Subject: Addendum # 1 – Centralized Receiving and Distribution Center Logistics Management Services Request for Proposals - Sacramento International Airport

Addendum #1 to the Centralized Receiving and Distribution Center (CRDC) Logistics Management Services Request for Proposals (RFP) at Sacramento International Airport (Airport) includes: 1) a revised timeline; and 2) questions and answers for all questions received by the December 11, 2019 deadline, including those from the Mandatory Pre-Proposal Conference held on December 5, 2019.

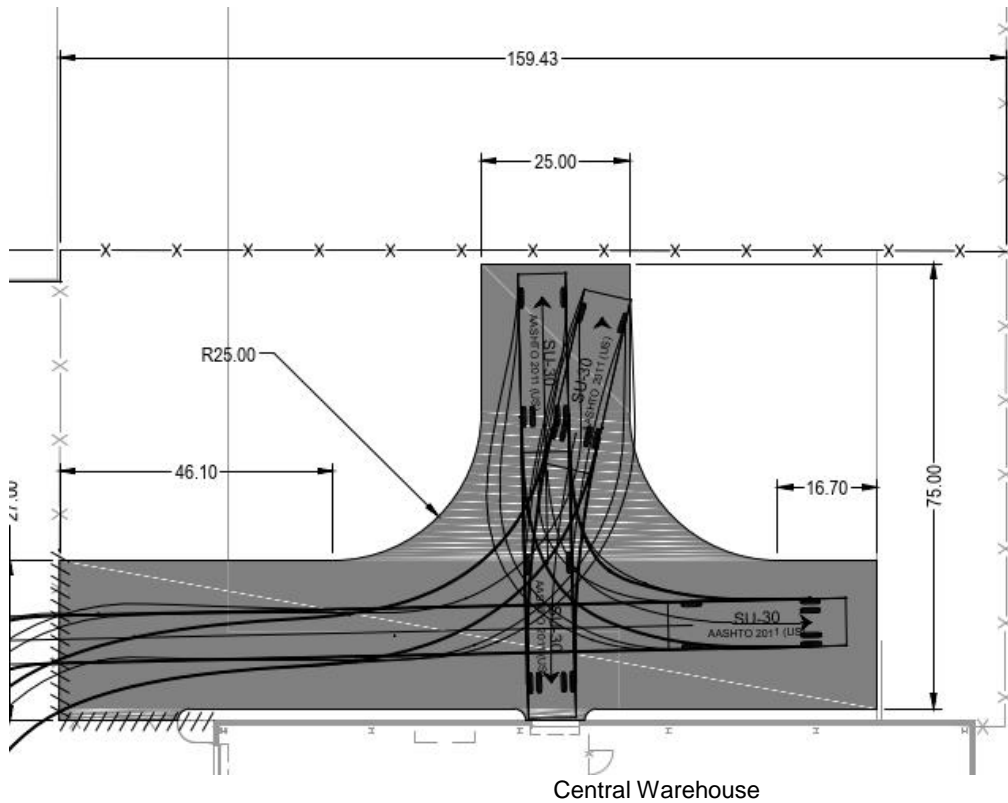
36. What are the dimensions of the airside area needing to be paved?

Answer: The size of the area to be paved is based on the selected proposer's needs and Department requirements to ensure airfield safety and the minimization of FOD. The Department previously identified an area with the dimensions shown below as the proposed area to be paved; however, the drawing is being provided for informational purposes only. It will be incumbent upon each proposer to determine how much paving will be required to meet its operational needs.
